RECOMMENDATION REPORT

City Planning Commission

LOCATION: 1515 South Veteran Avenue (1505, 1507, 1509, 1511, 1513, 1517, 1519, 1521, and 1523 South Veteran Avenue)

Case No.: CPC-2022-7045-CU3-DB-DRB-SPPC-HCA
CEQA No.: ENV-2022-7046-CE

17 Apr 2024
 COURTYARD ELEVATION

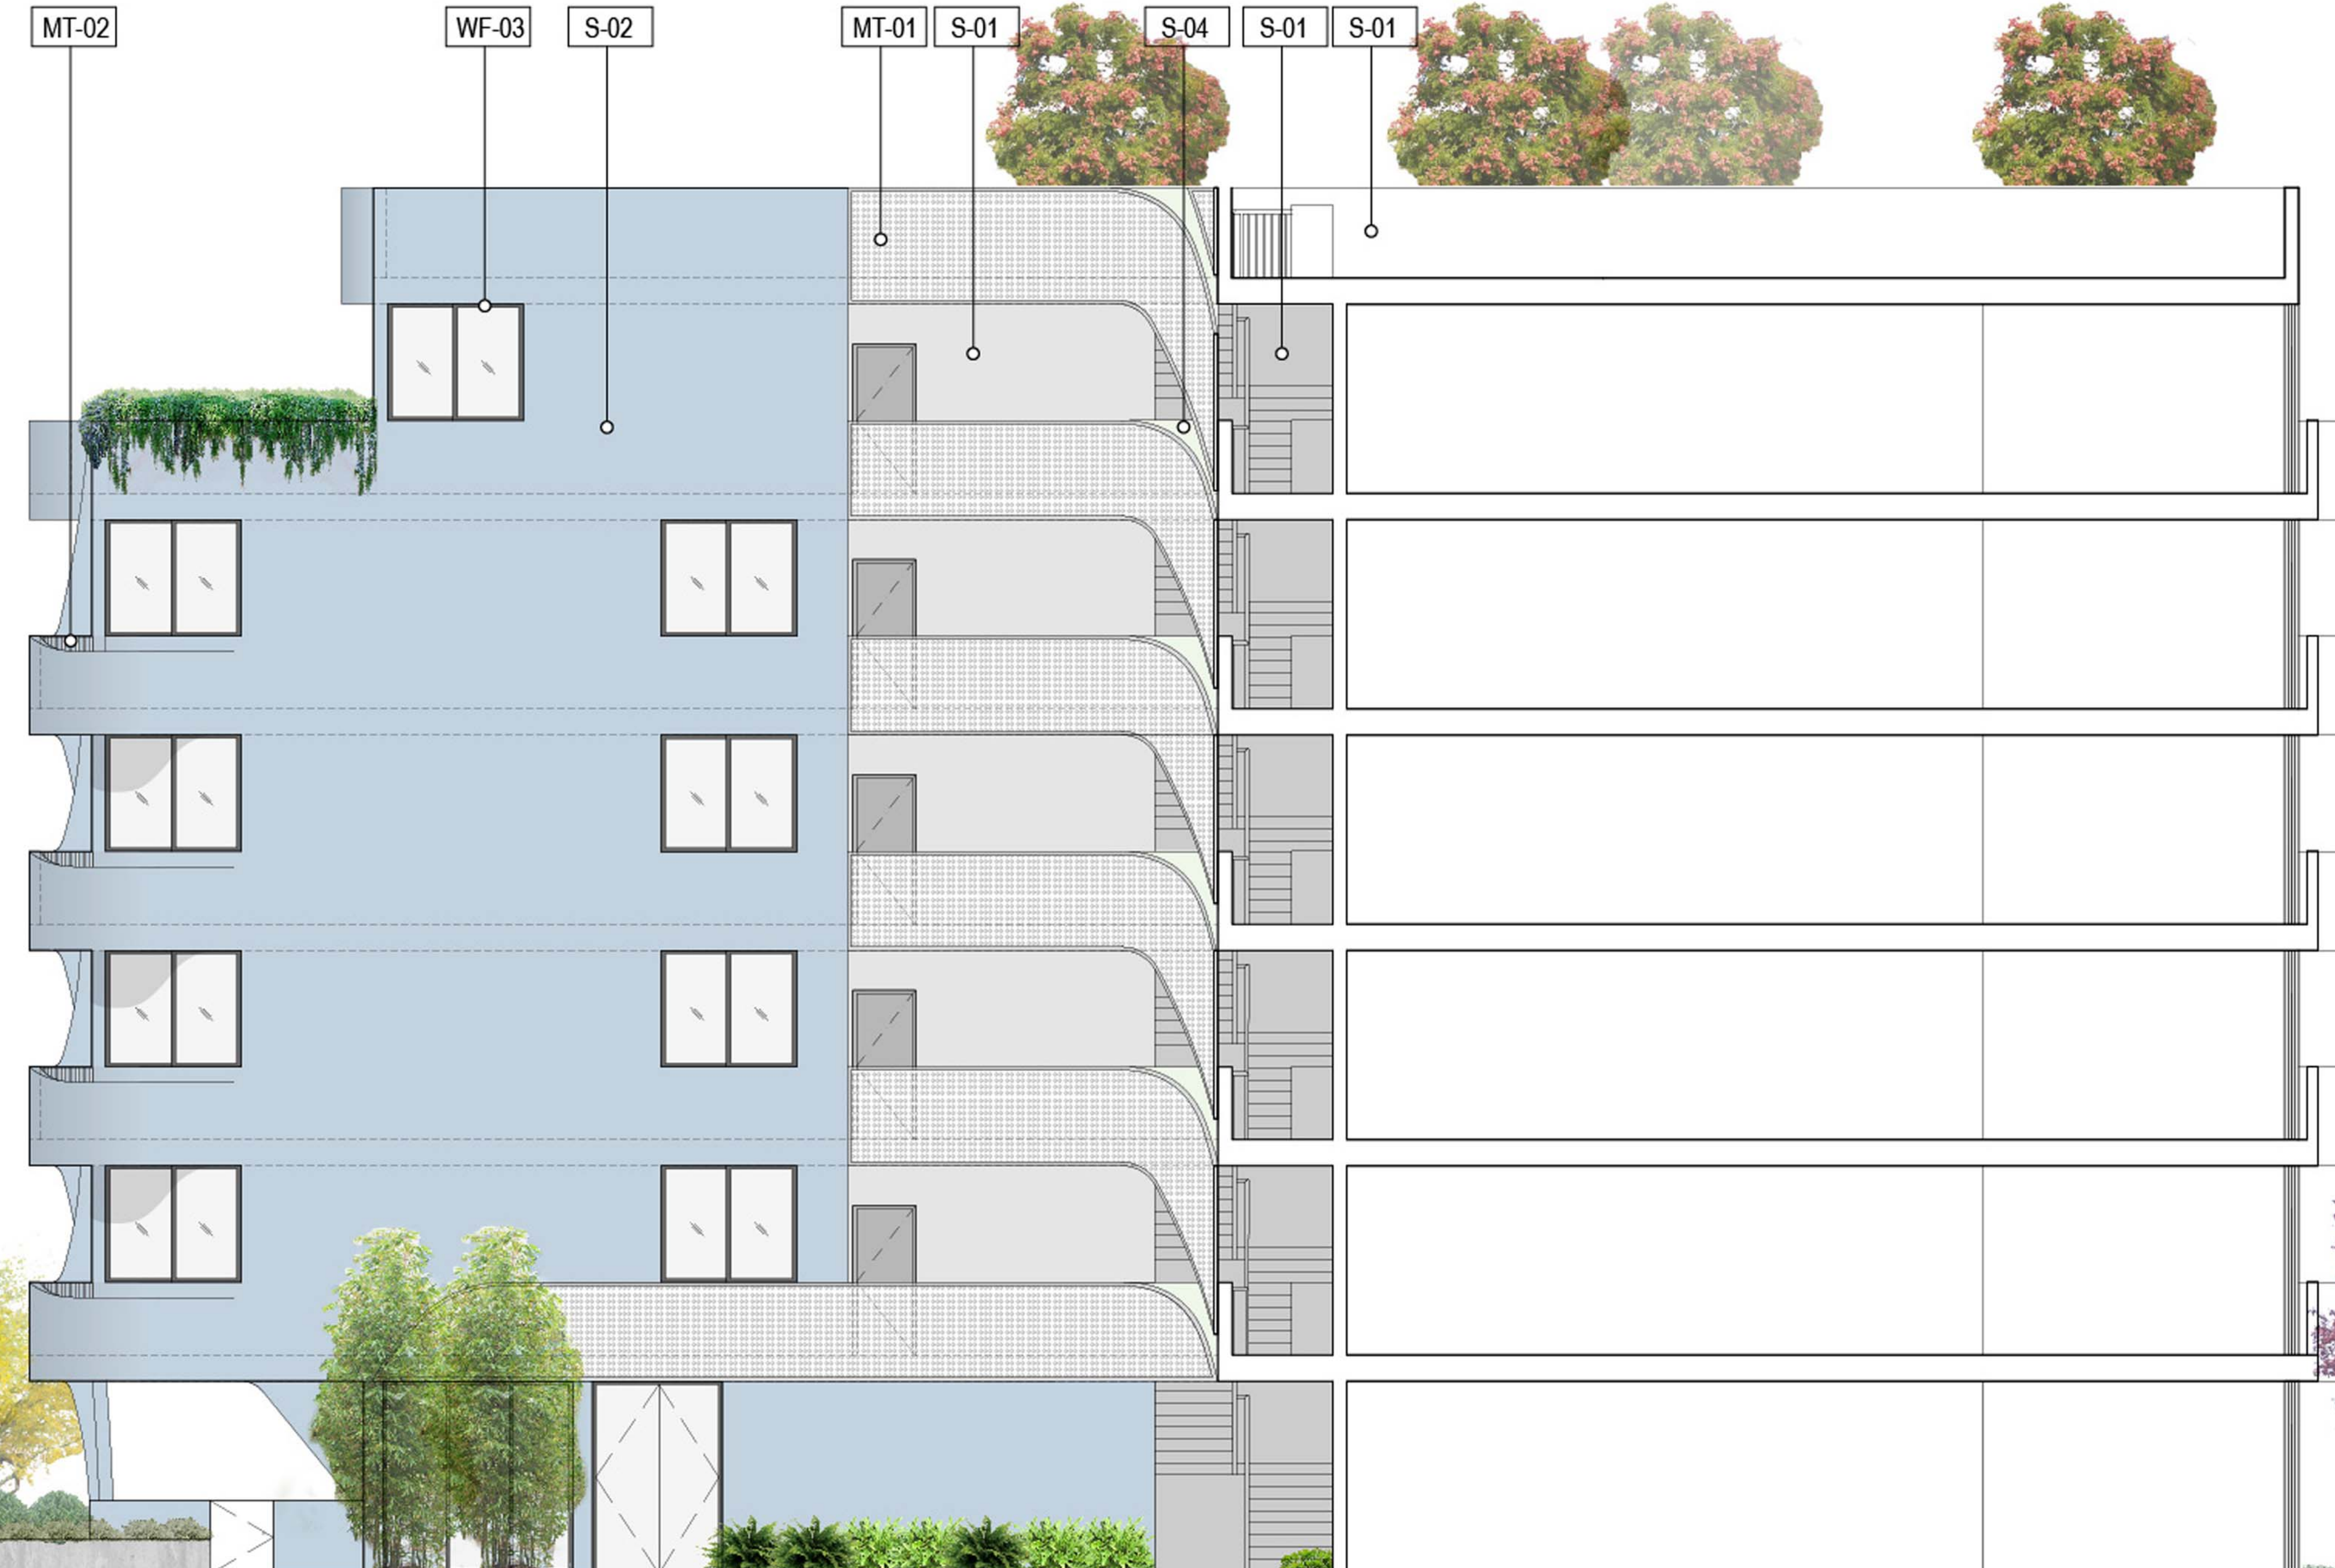
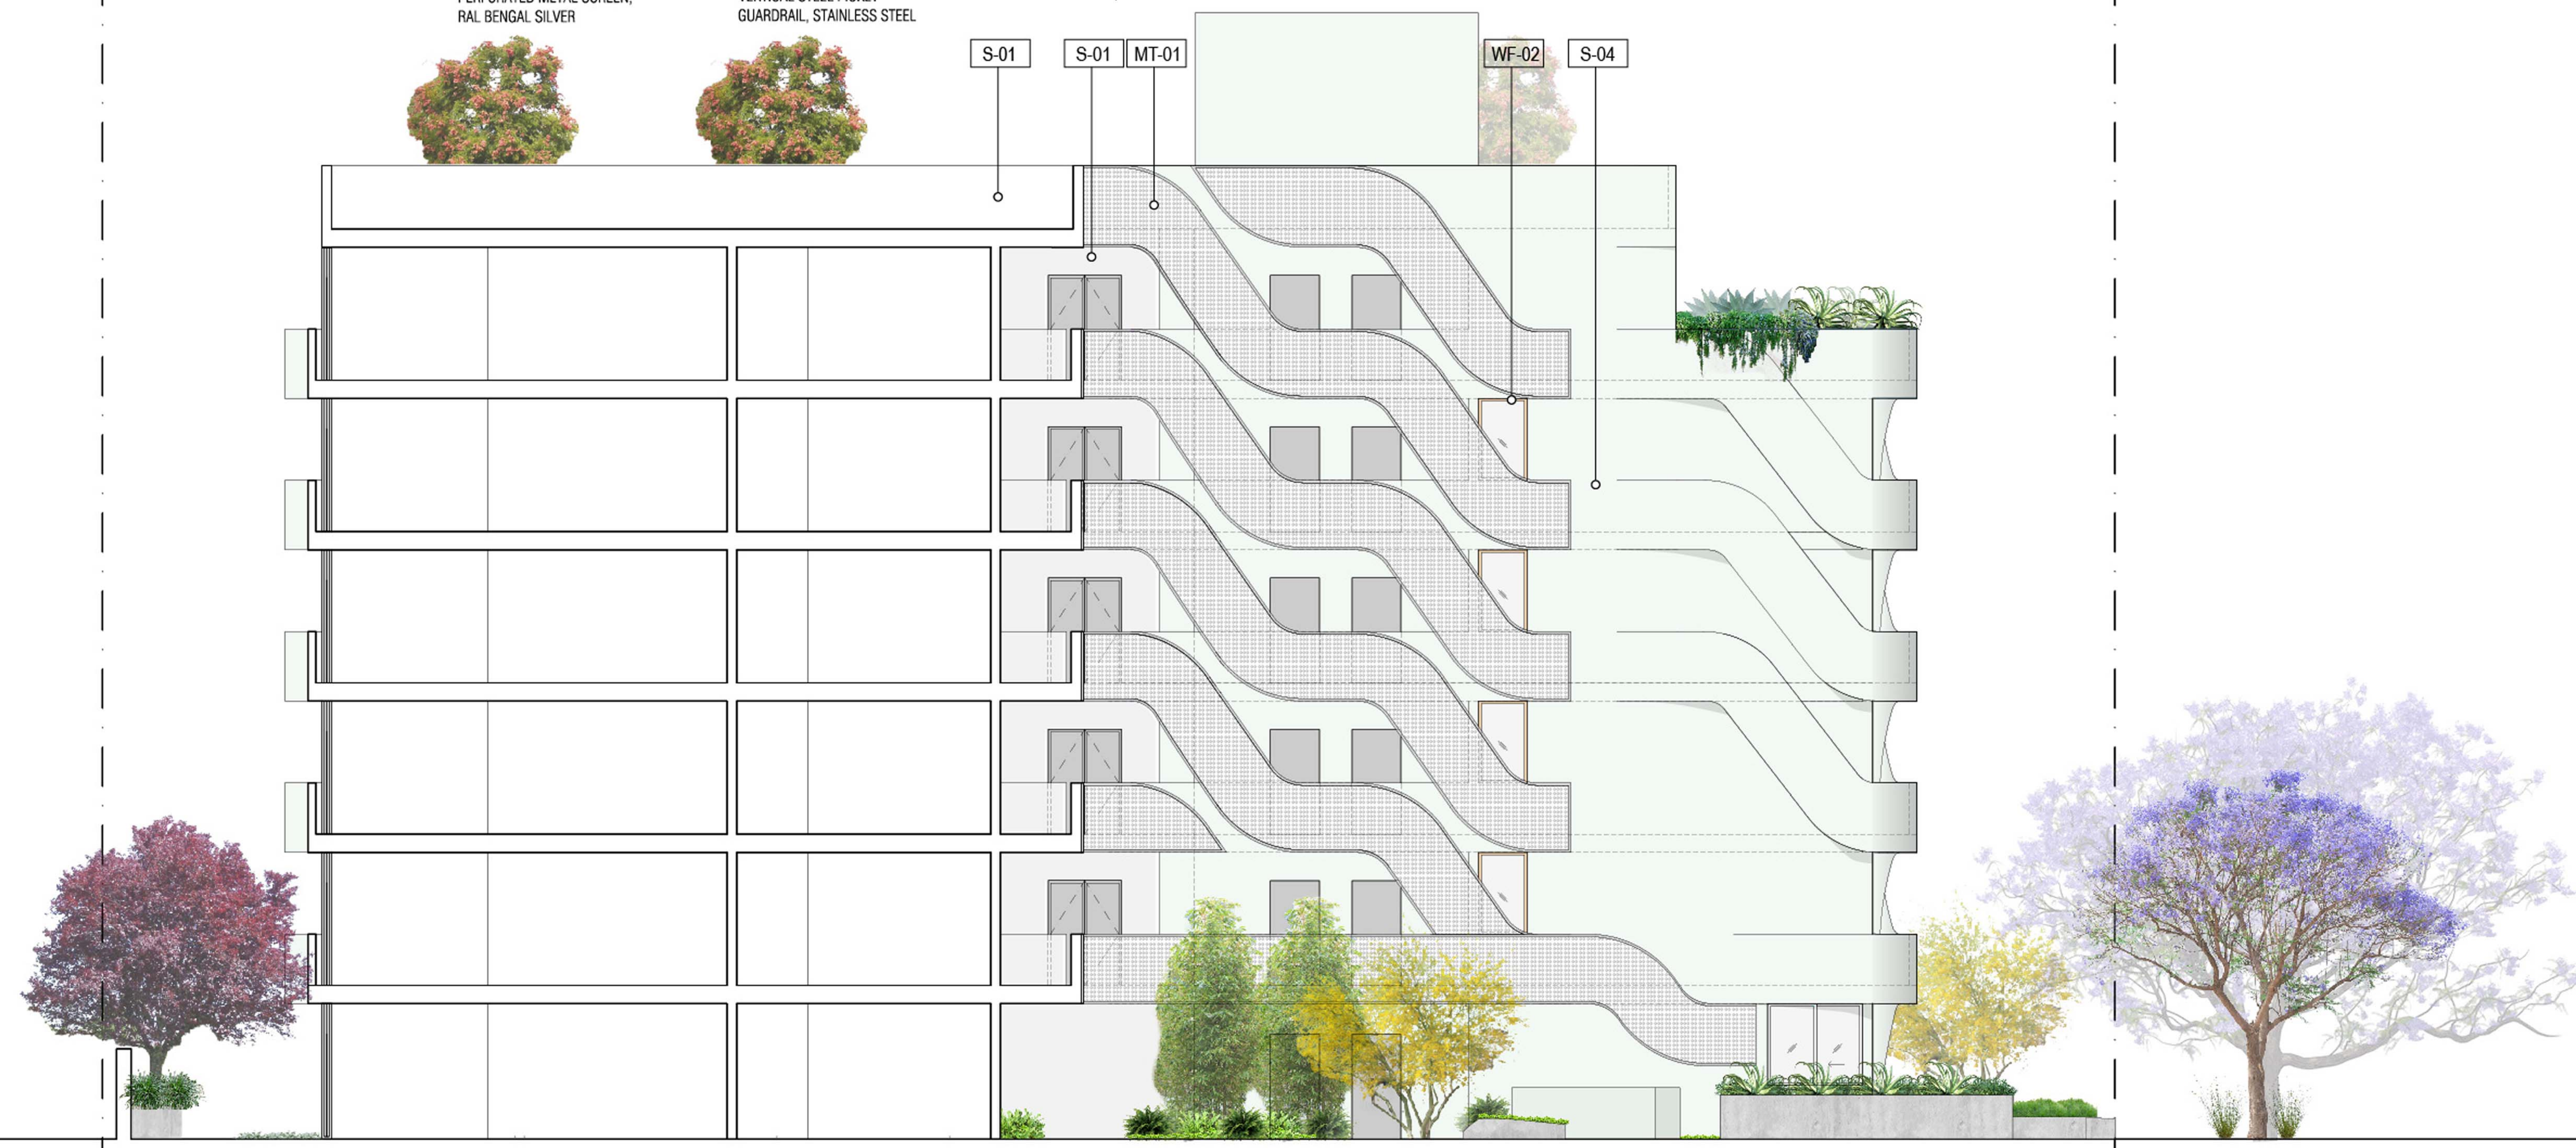
- Really difficult to understand from the elevations how or where the perforated metal is used on the upper floors above the courtyards; if used on part of the back wall of the courtyards, the plans don't seem to be depict this condition of part solid, stucco wall and part perforated metal.

The applicant was generally responsive to the comments and revised the plans to address those related to the main entrance, courtyard, transformer, and artificial turf. The applicant provided written clarification on issues raised about the amount of automobile parking spaces, type of housing, cantilevered building corner over the driveway lanes, and trash bins. The applicant also confirmed that they have met with LADBS and Fire Department regarding comments on the side yard openings, access and ingress/egress, and trash chutes and that the proposed project will comply with their requirements. Finally, the applicant clarified that building permits for the proposed project was submitted to LADBS prior to 2023 and is therefore exempt from solar requirements pursuant to the 2019 Building Energy Efficiency Standards.
